ADDENDUM NUMBER 001

Date: April 6, 2026
EDR Project No.: **21004**

COPA LIFEGUARD HEADQUARTERS
303 Ninth Street
Port Aransas, Texas 78373

Addendum 1-1
EDR Project No. 21004
04/06/2026

RETAINING WALL DETAIL
SCALE: 1/2"=1'-0"

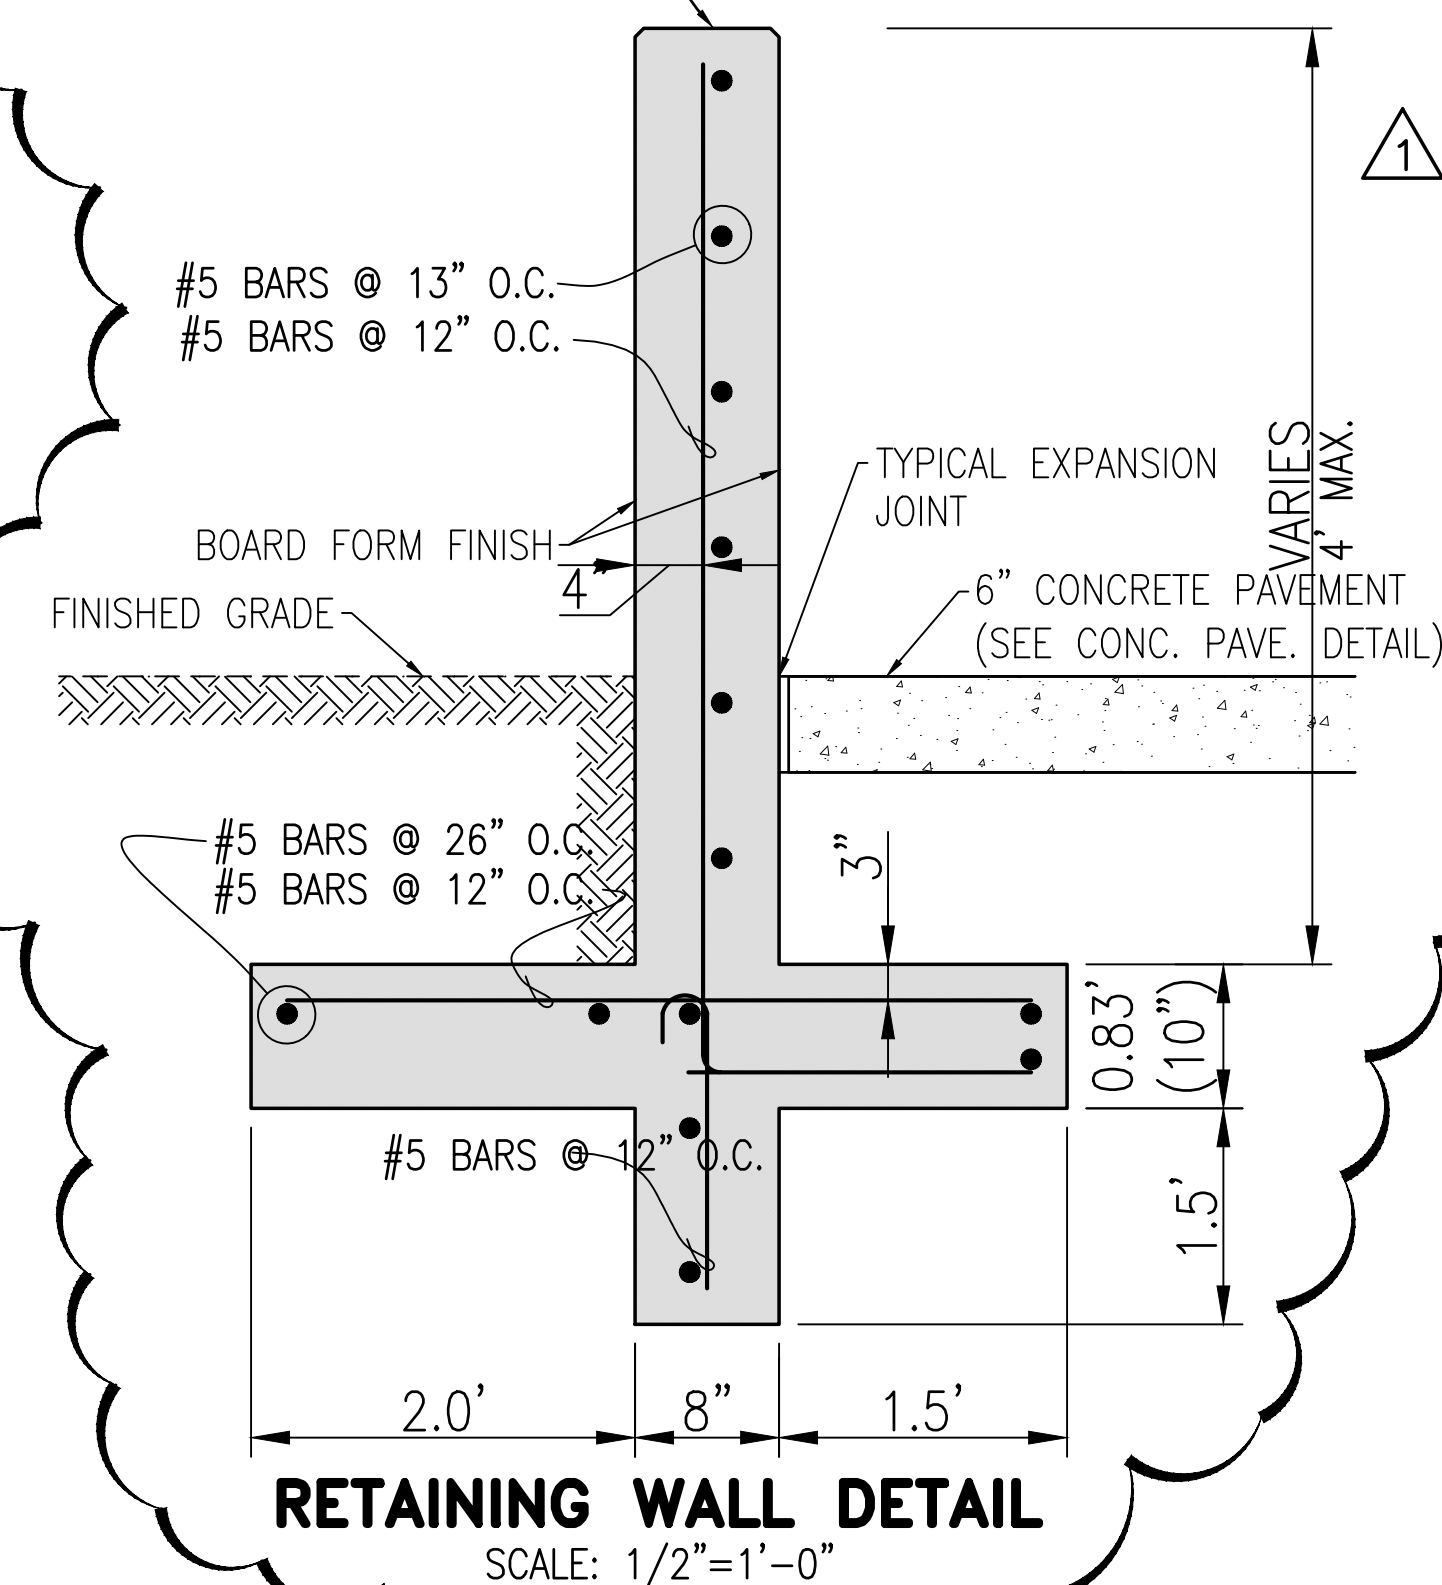
Sheet 6 of 10 – Paving Details:

1. Detail of retaining wall has been added.
2. Detail clarifying doweling to existing concrete has been added.
3. Detail of 6" L-Curb has been added.

S1-1

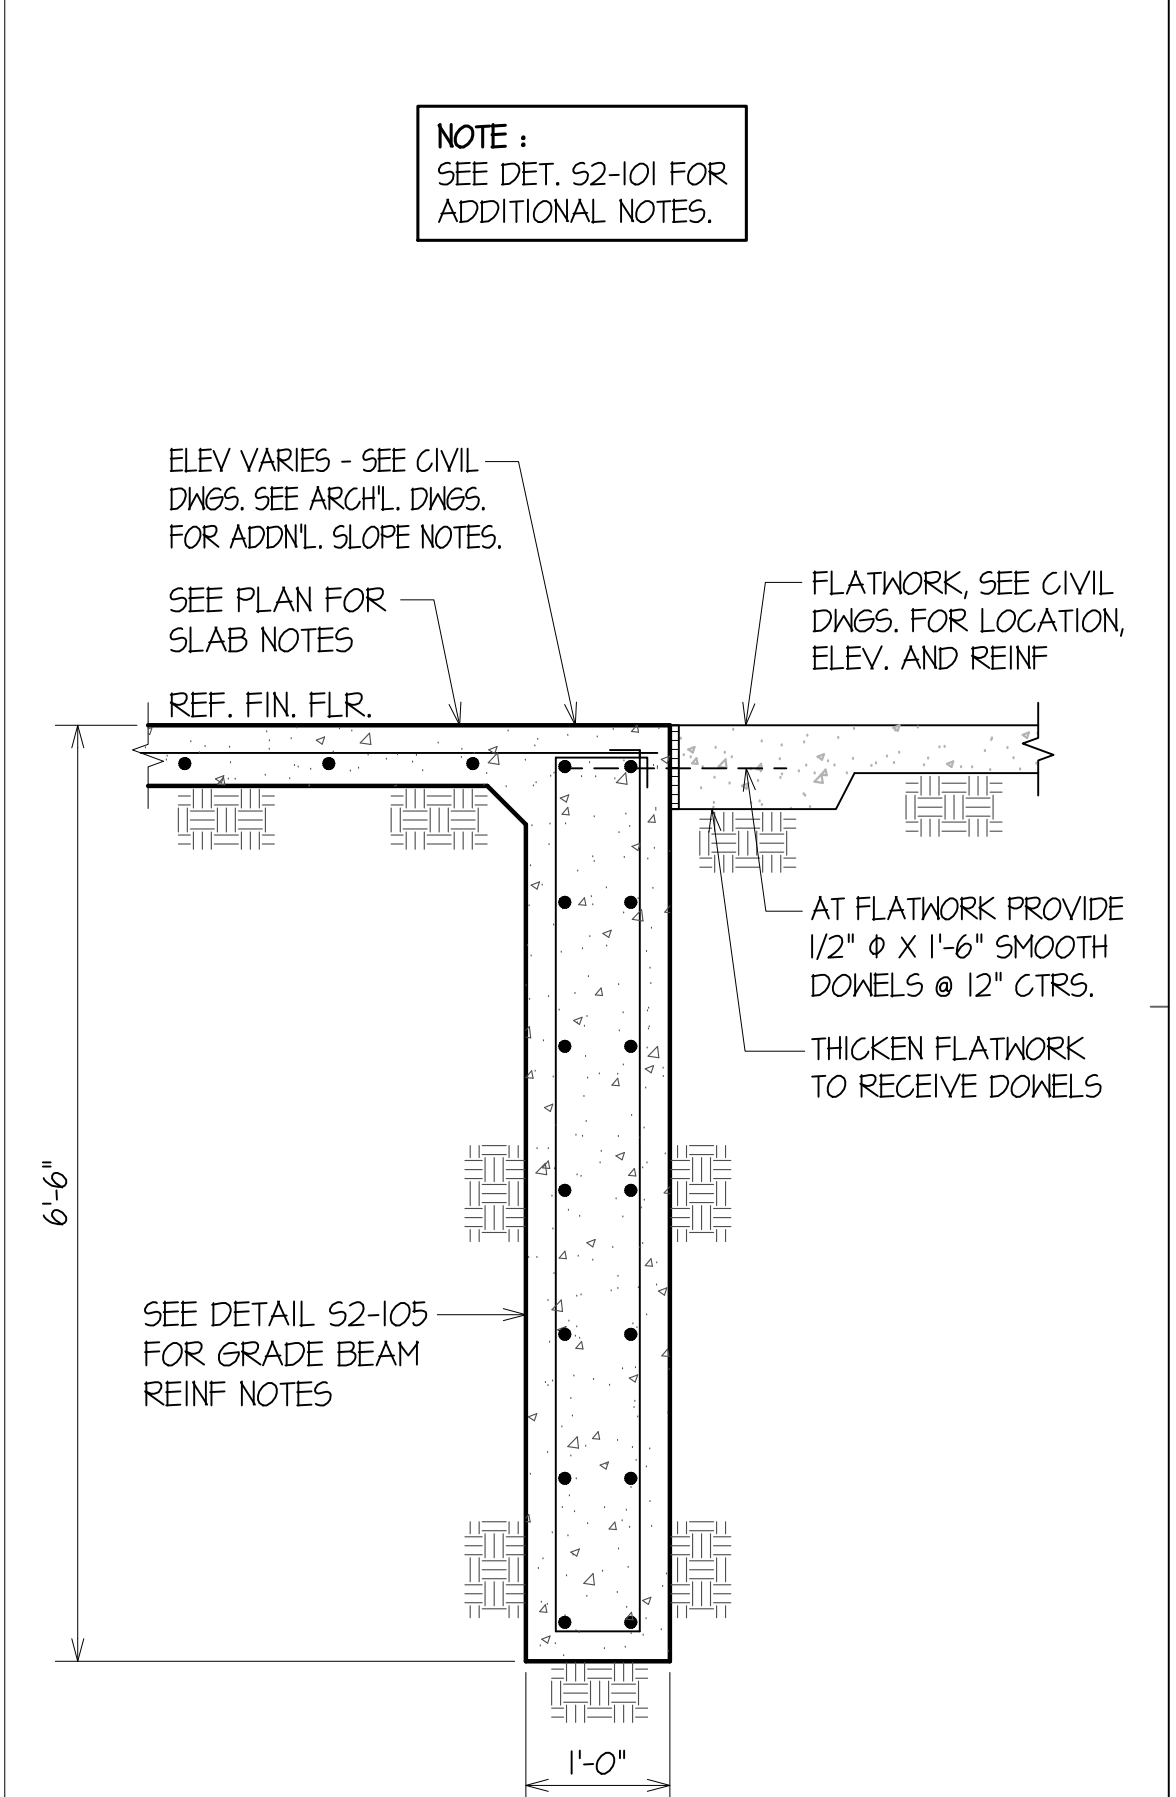
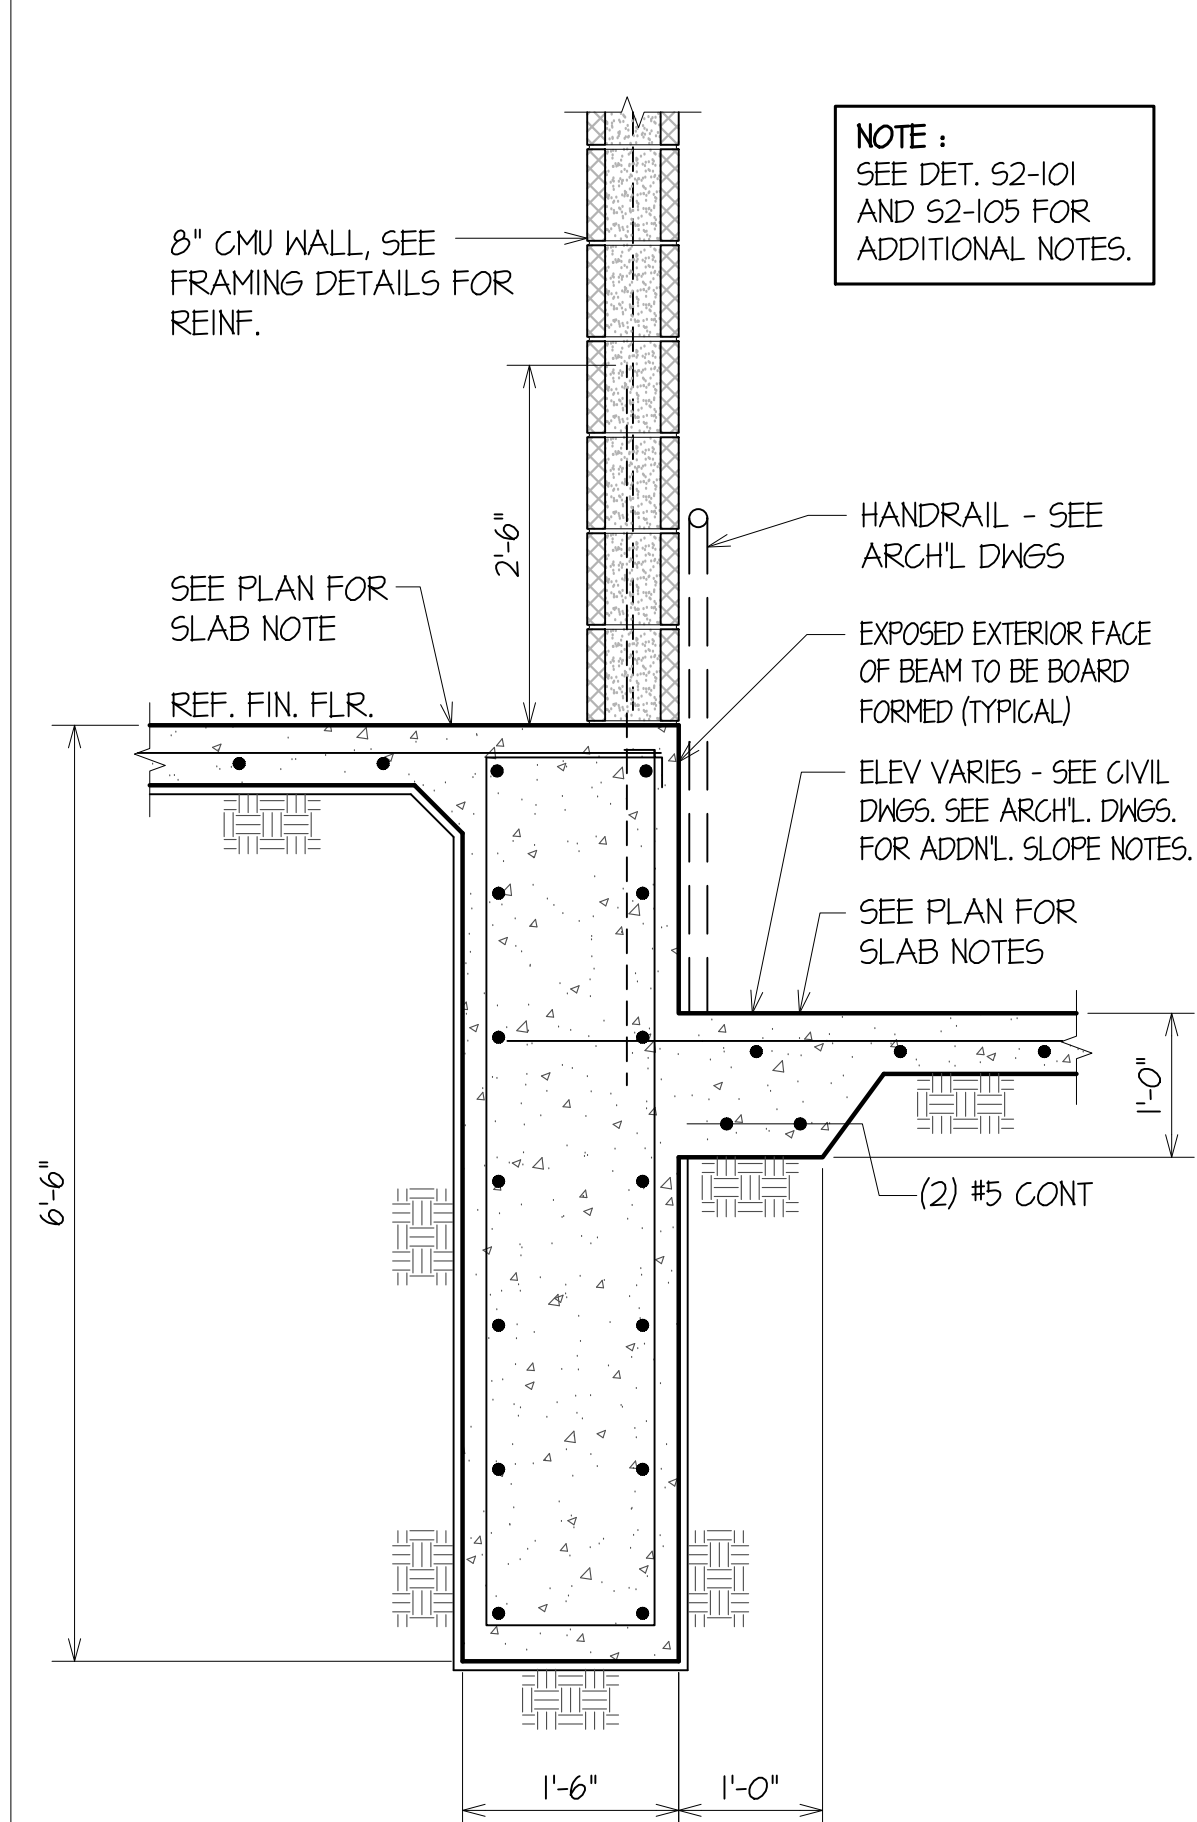
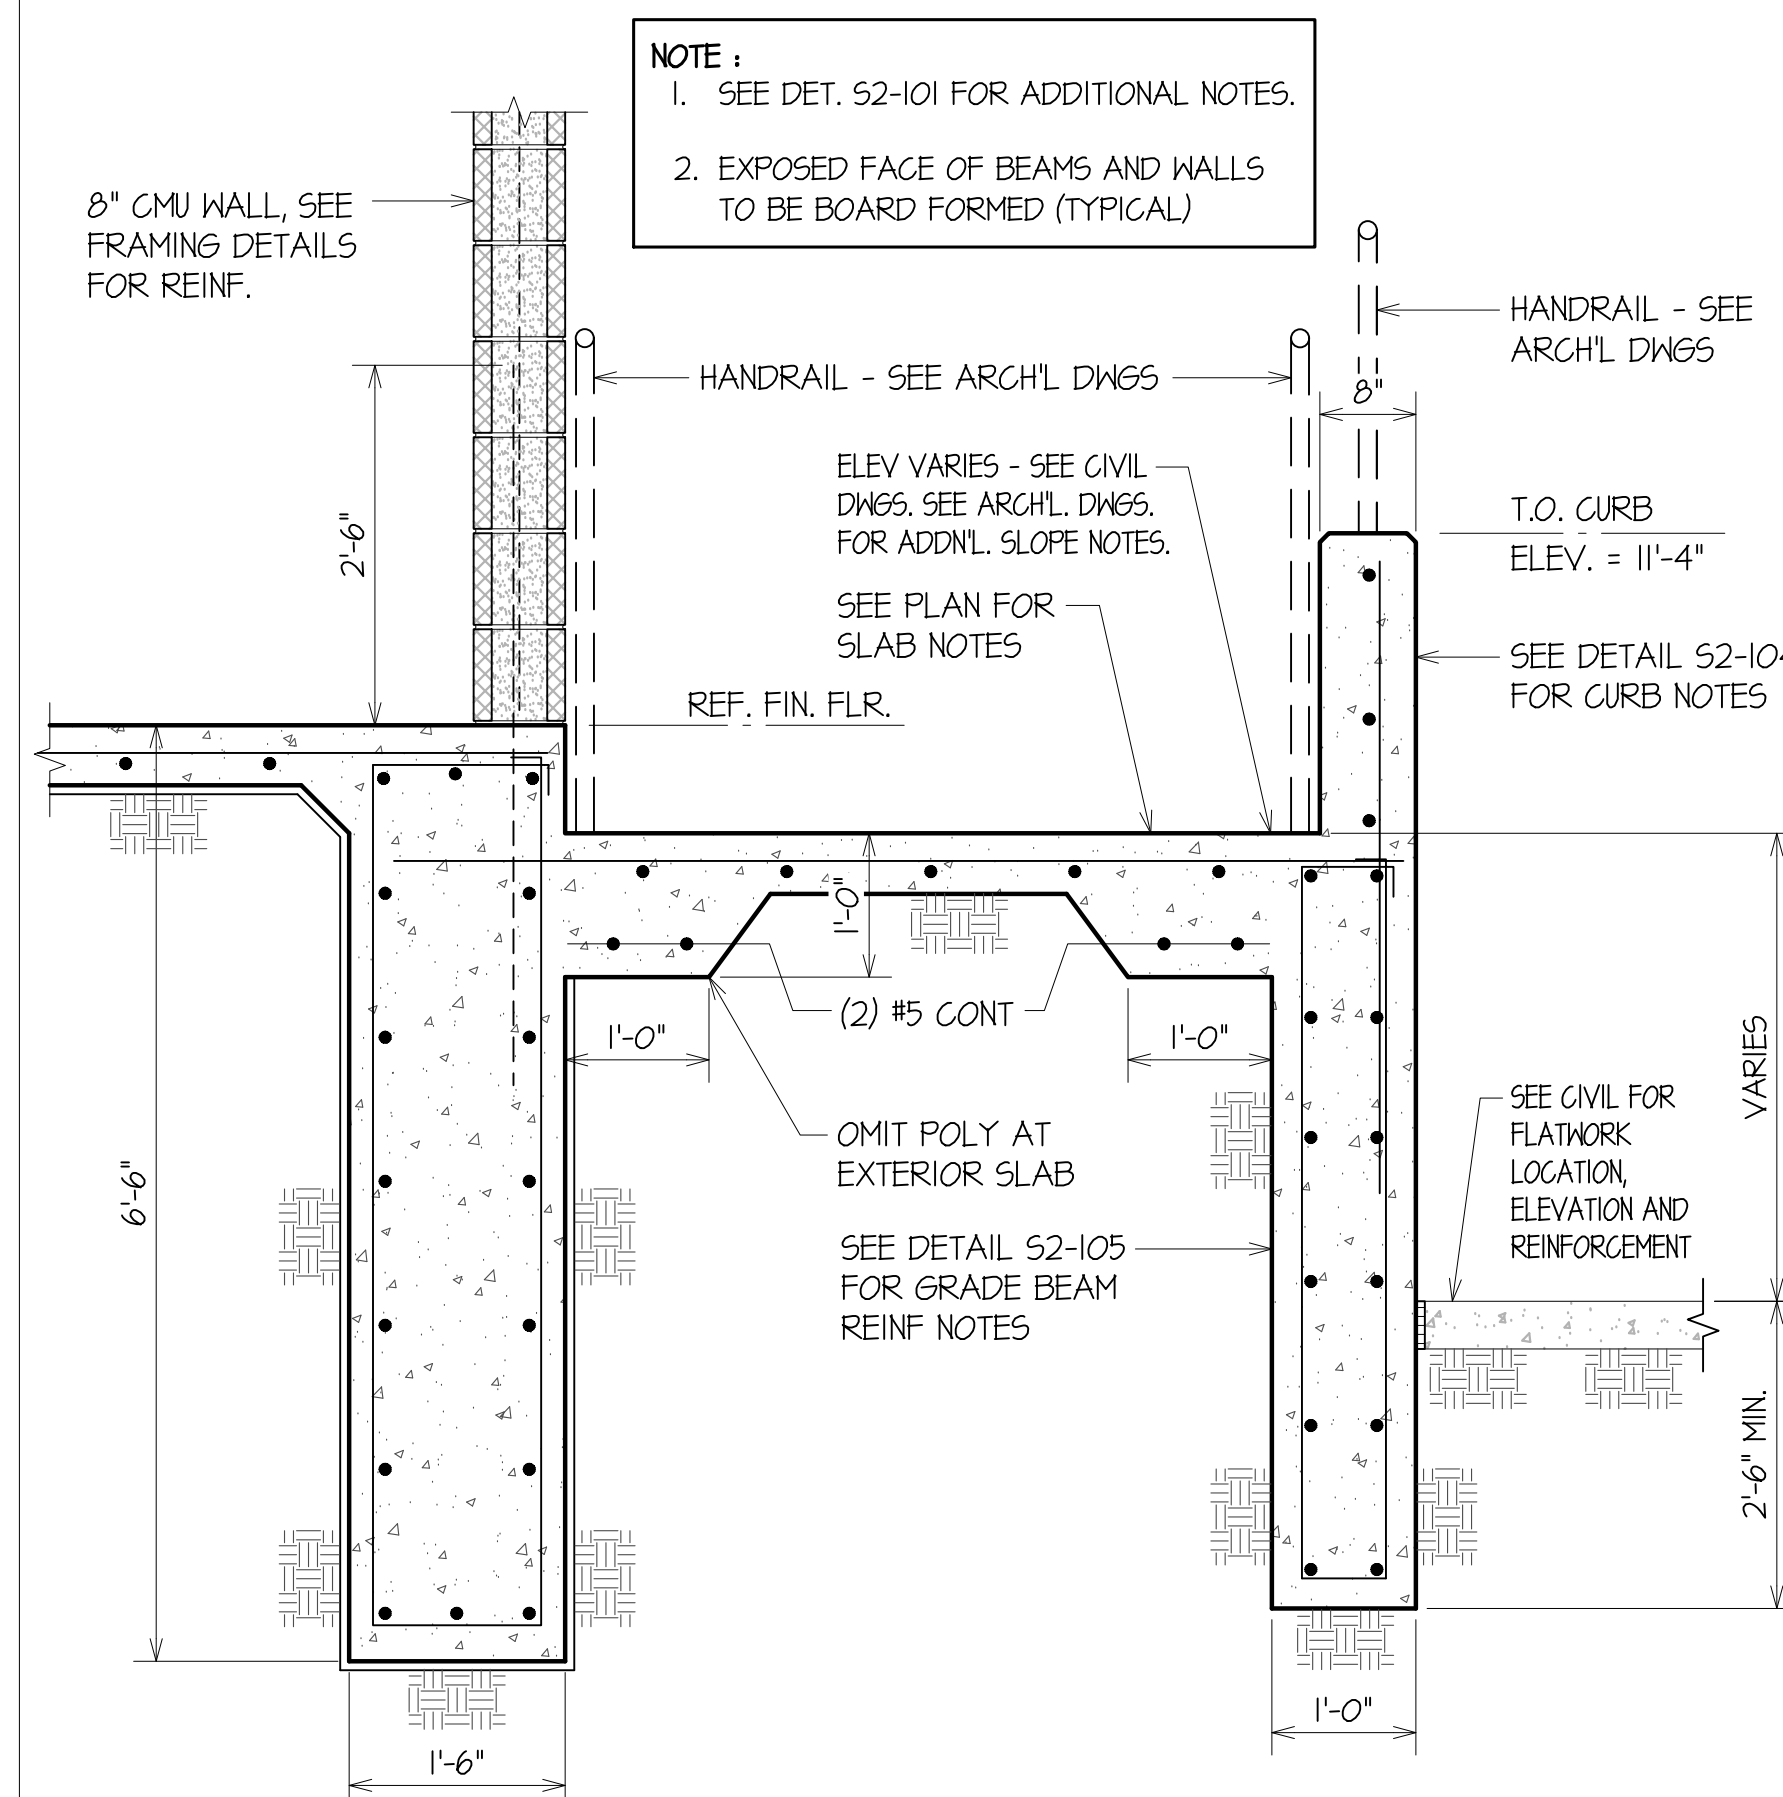
Sheet S1-1 – Foundation Plan and Roof Framing Plan

- a.) Hanger channel and details added at change in roof elevation along Grid 4.
- b.) Uplift and wall pressure diagram added to plan.
